IAEWESTWIND

SERVICE BULLETIN

1124 SERVICE BULLETIN INDEX

FIGURE 1: VERTICAL GYRO INSTALLATION.
-RE 1: Single Instl
-RE 3: Dual Instl. (1 of 2)

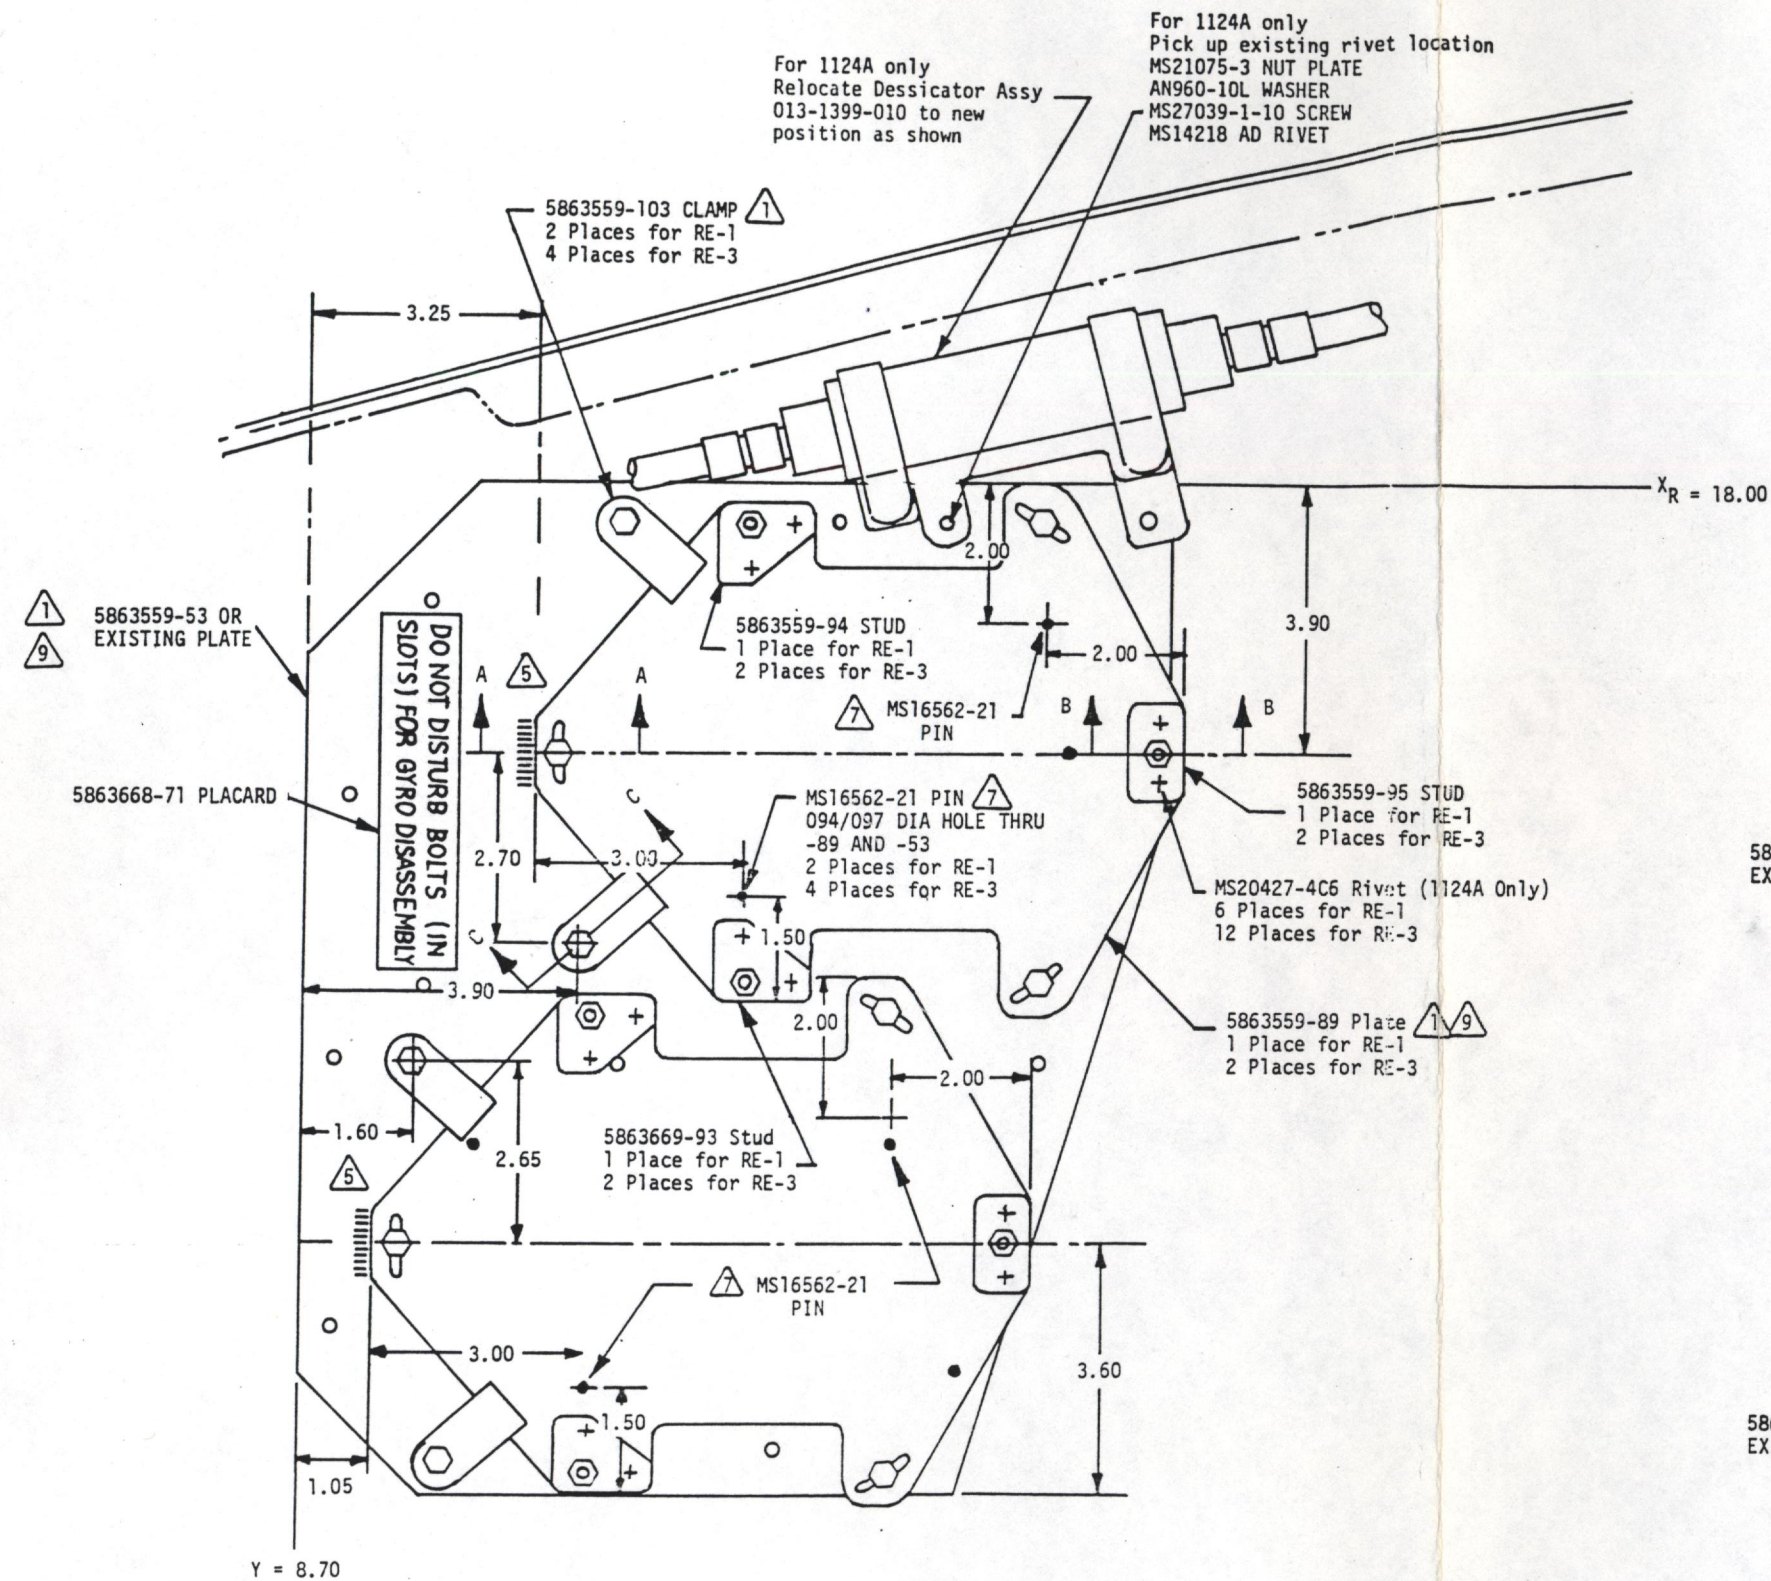
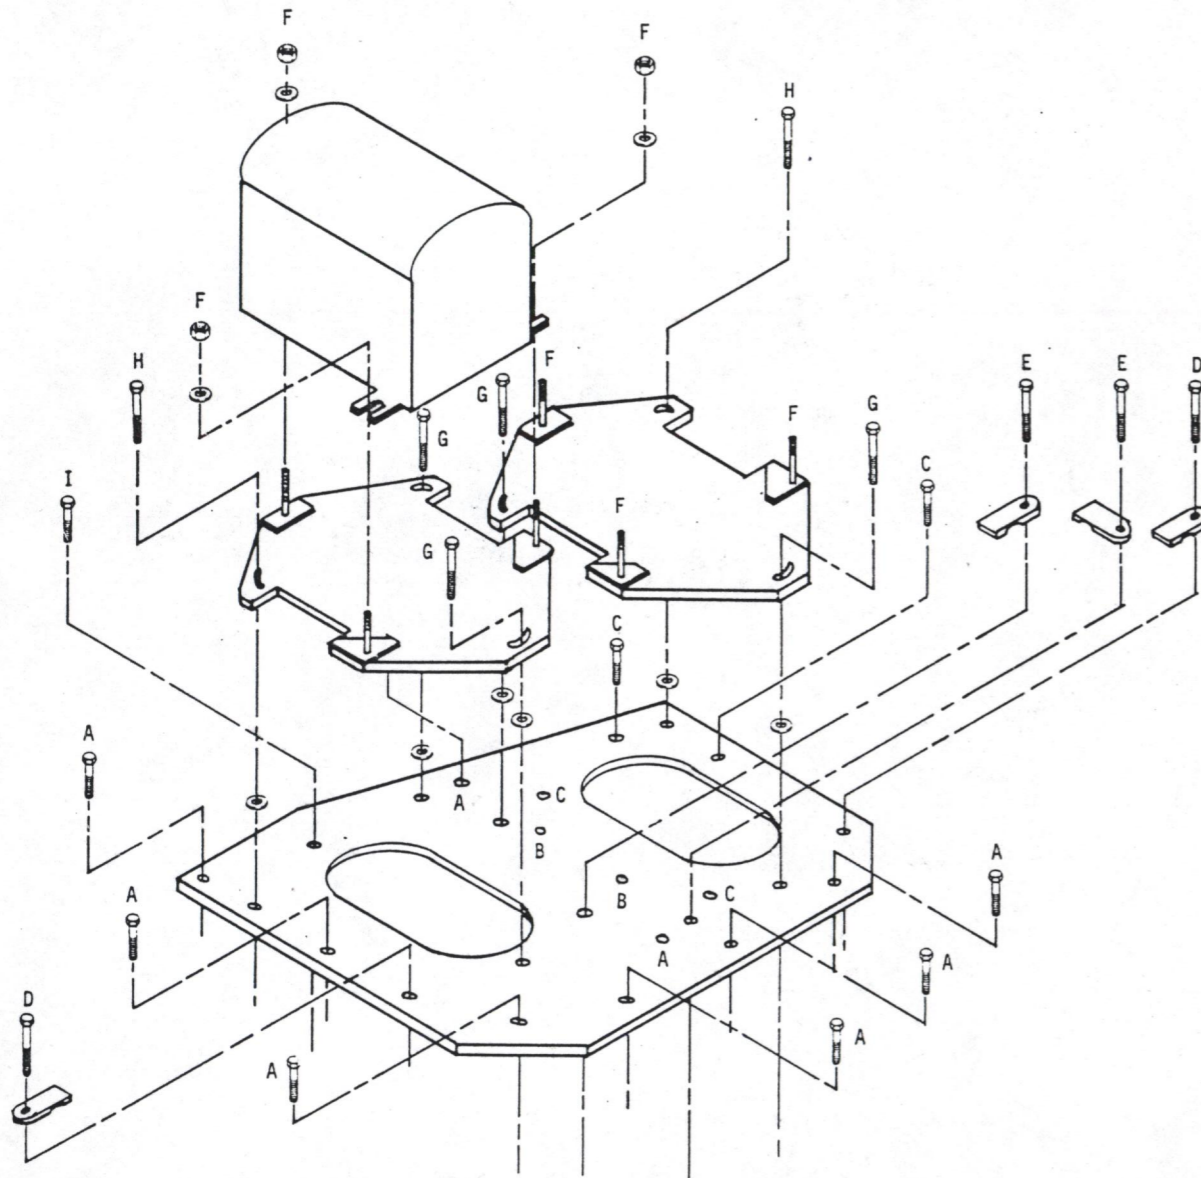
- E. Install P/N 5 863559-53 base-plate, P/N 5 863559-89 skew-plate assembly(s) and P/N 5 863559-103 clamps per Figure 1. Install nut-plates through oxygen bottle access cover or nose deck structure only (not through P/N 5 863559-53 base-plate) using MS14218AD rivets.

If skew-plate(s) are 1/8 inch in thickness, drill out rivets securing the three stud assemblies per plate and replace them with one each P/N 5 863559-93, 94, 95 per skew-plate using MS20427-4C6 rivets (Figure 1).

- F. Lay out and install P/N MS21075-3 nut-plates per Figure 1 using MS14218AD rivets. Install all nut-plates on bottom of nose deck structure and bottom of oxygen bottle access cover (not on P/N 5 863559-53 base-plate).

- G. Install oxygen bottle access cover base, plate P/N 5 863559-53, skew-plate(s) P/N 5 863559-89, and clamps P/N 5 863559-103. Refer to Figure 1 for hardware information as well as which base-plate holes require countersinking.

- H. Relocate desiccator assembly per Figure 1.
- I. Reinstall gyro(s) and level per Service Information Letter No. 1124-22-038 "Vertical Gyro Adjustment Procedure." Leveling can be accomplished by adding AN960-PD10L washers under the gyro mounts (Figure 1, Section B-B). Grind washer faces as required to achieve proper thickness.

Figure 1 of 3

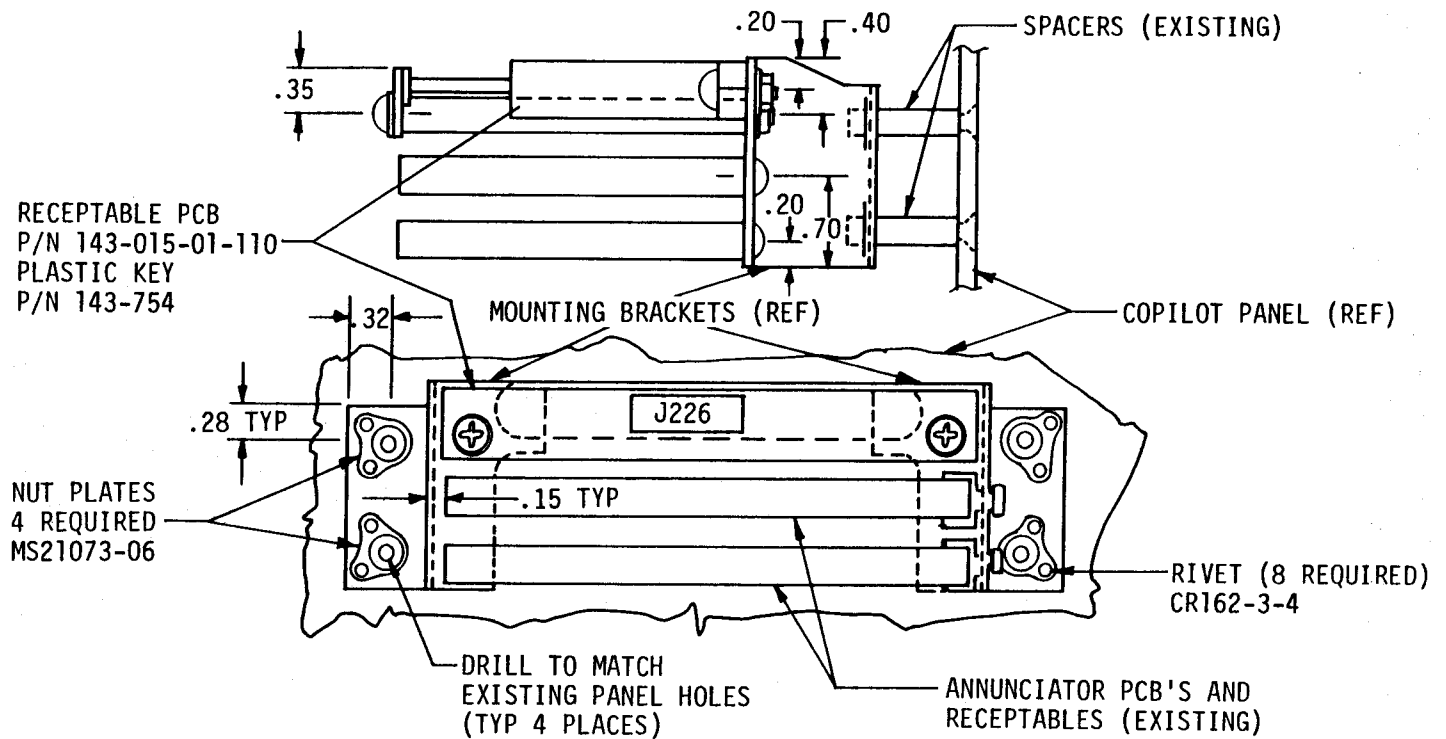
- (3) Remove existing diode board mounting brackets from stand-offs and discard brackets (retain hardware for following steps). Refer to Figure 1.
 - (a) Use brackets P/N 5883775-RE3 and 5883775-RE4 or locally fabricate new mounting brackets from standard and 10139-070-1 stock ALCLAD 2024-T3511 (two required - second (5883775-RE4) bracket opposite of Figure 1 view).

- (b) Use bracket P/N 5883775-RE5 or locally fabricate hold-down strap from .063 ALCLAD 2024-T6 stock per Figure 1.
- (4) Secure new brackets in place on instrument panel using hardware from step (3) above.

- (b) Drill holes in brackets and mount PCB receptacles using Loctite on screw threads. Mount pillars in same manner with screws and spring washers as shown on Figure 1.

Figure 2 of 3

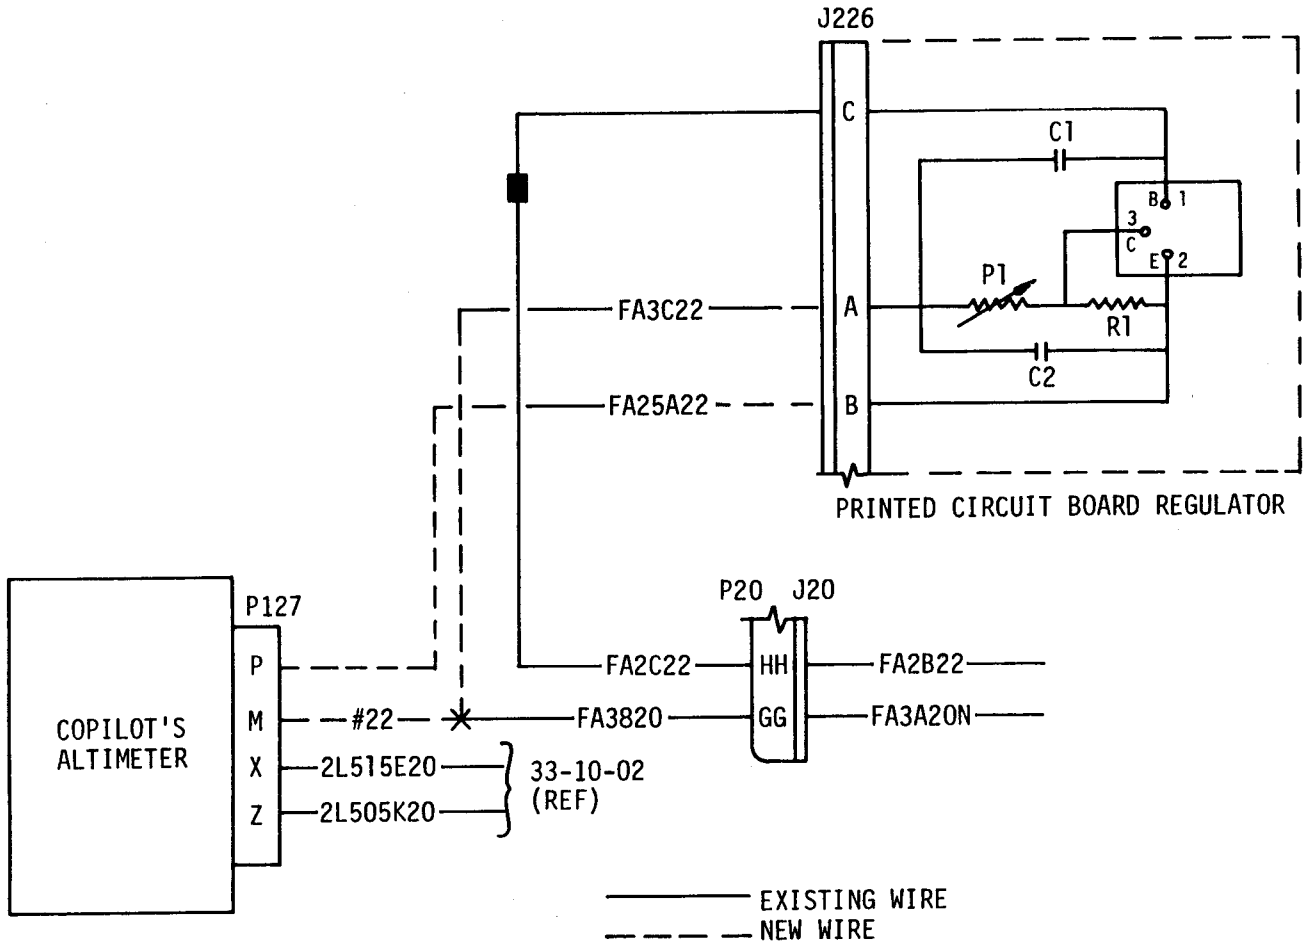
- (a) Align printed circuit board (PCB) receptacles on mounting brackets as per Figure 2 and mark brackets for drilling of mounting holes. Follow same procedure for pillars used for securing regulator board.

VIEW LOOKING OUTB'D R.H.S.
FIGURE 1

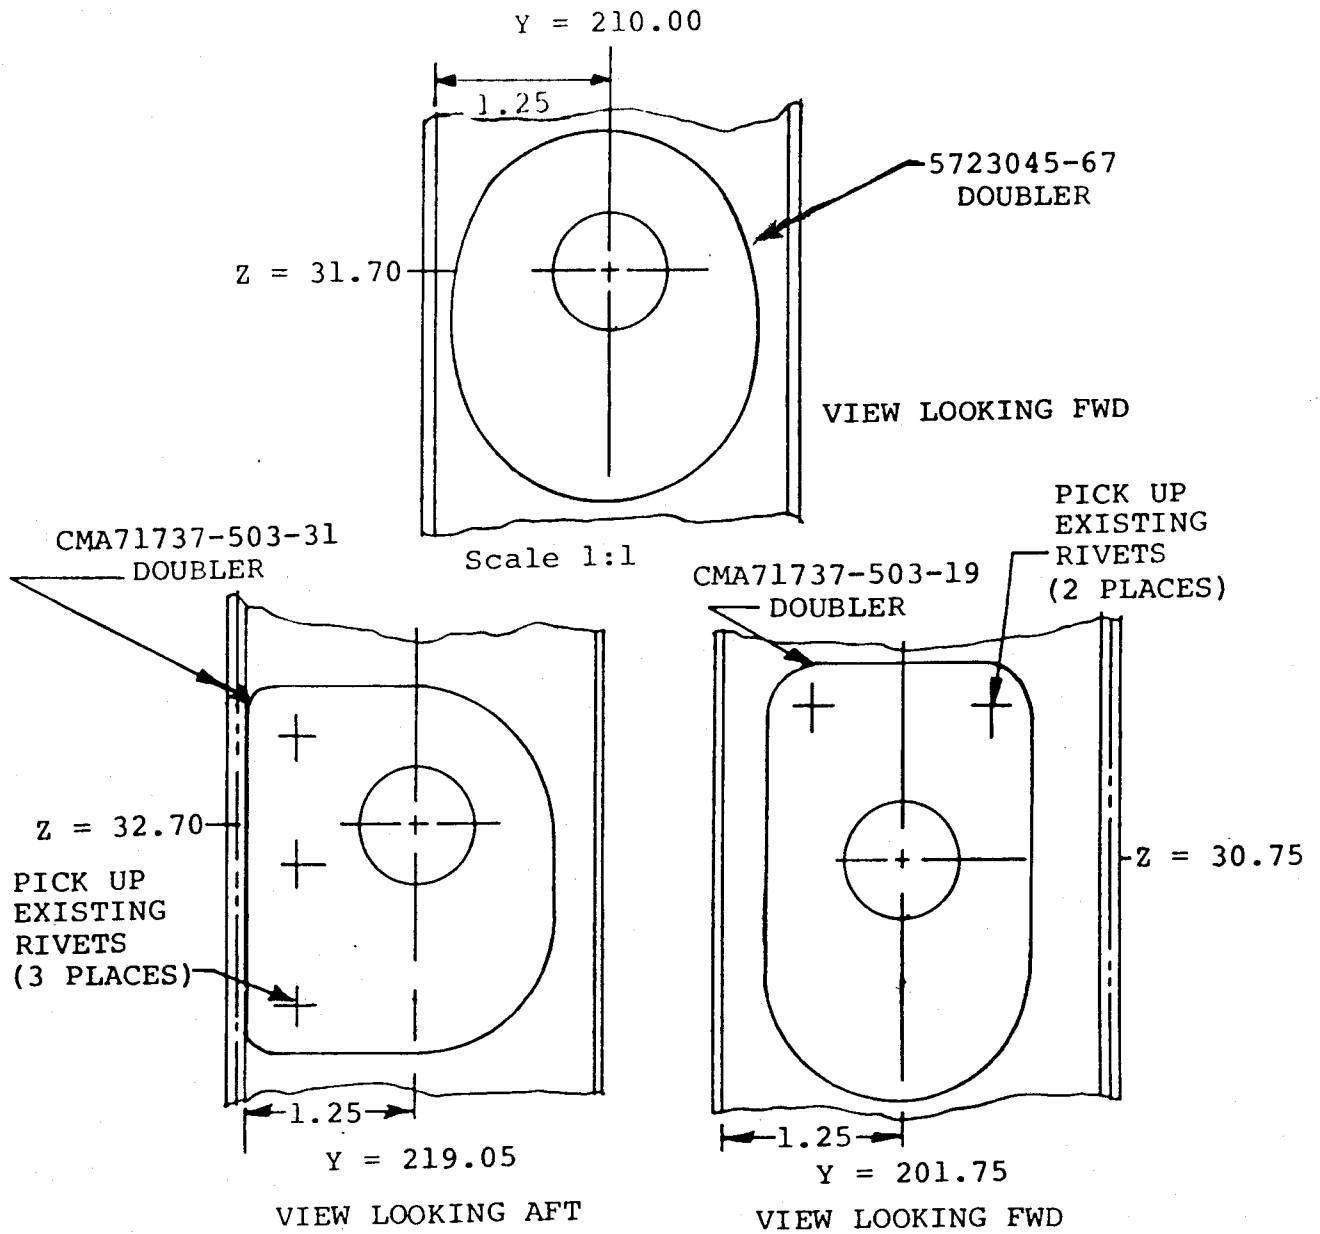
- (1) Disconnect tube at tee fitting adjacent to static port and at elbow fitting between frame Stations 219.05 and 223.75. Refer Figure 1.
- (2) Remove clamps supporting tube and remove tube.

**DOUBLER INSTALLATION FRAME 194.00
FIGURE 3**

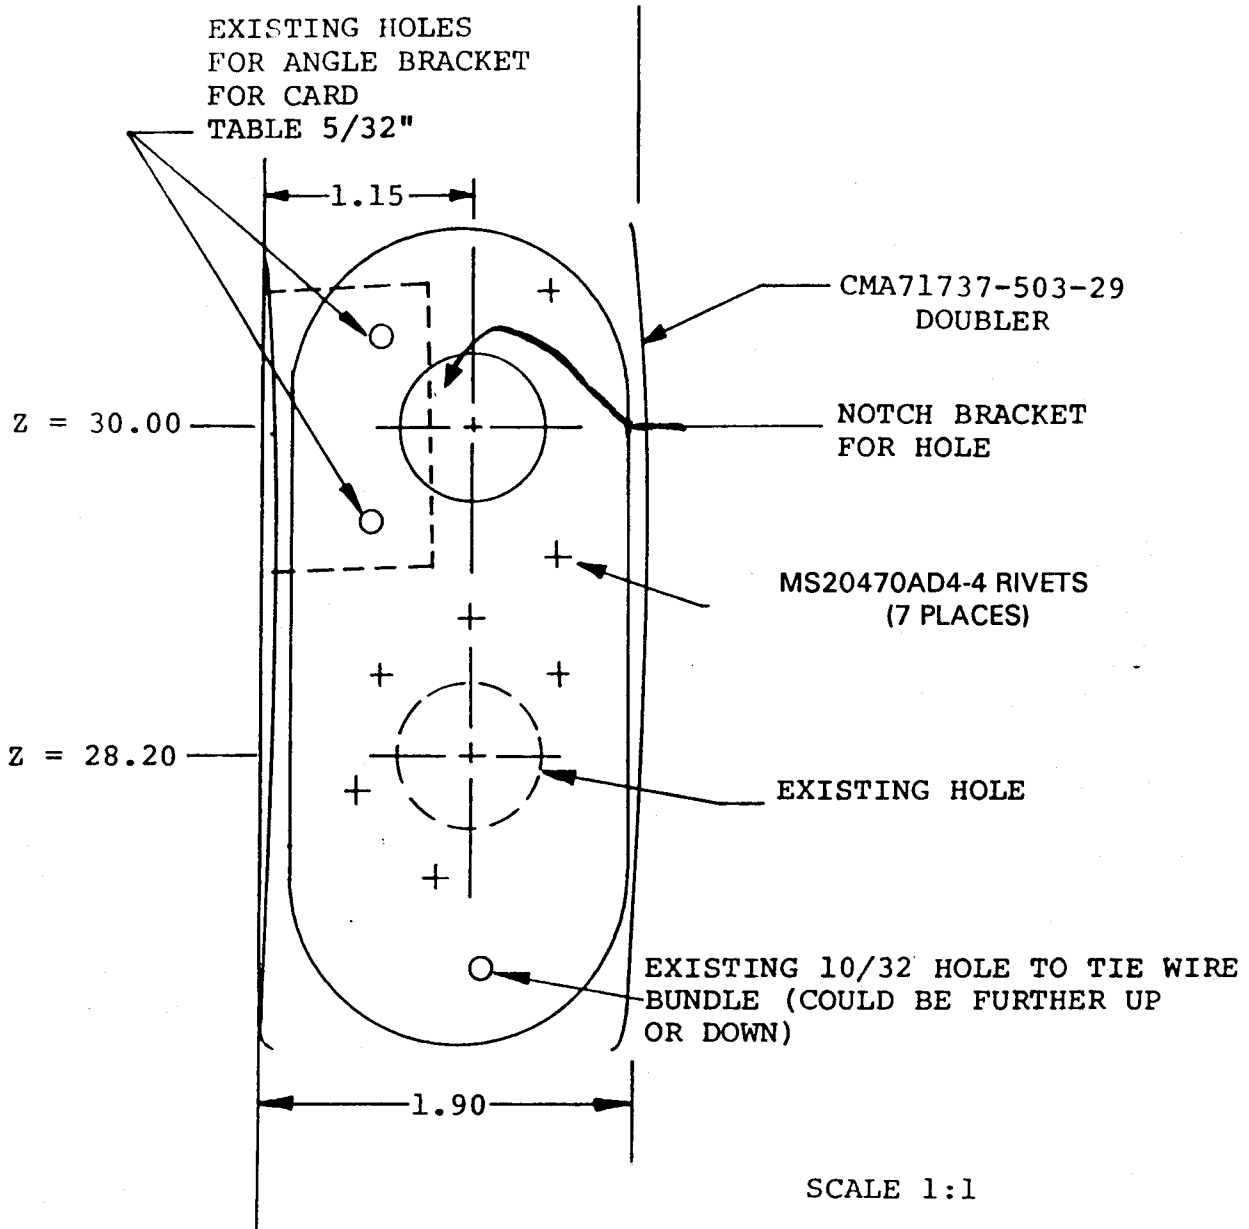
- (b) Doubler for frame at Sta. 194 must be of sufficient length to cover the existing hole at Z station 28.20. Refer to Figure 3.
 - (c) Install NAS1033-A3 nutplate on aft side of frames at Sta. 210.00 and 201.75 for Adel clamp to support tube.
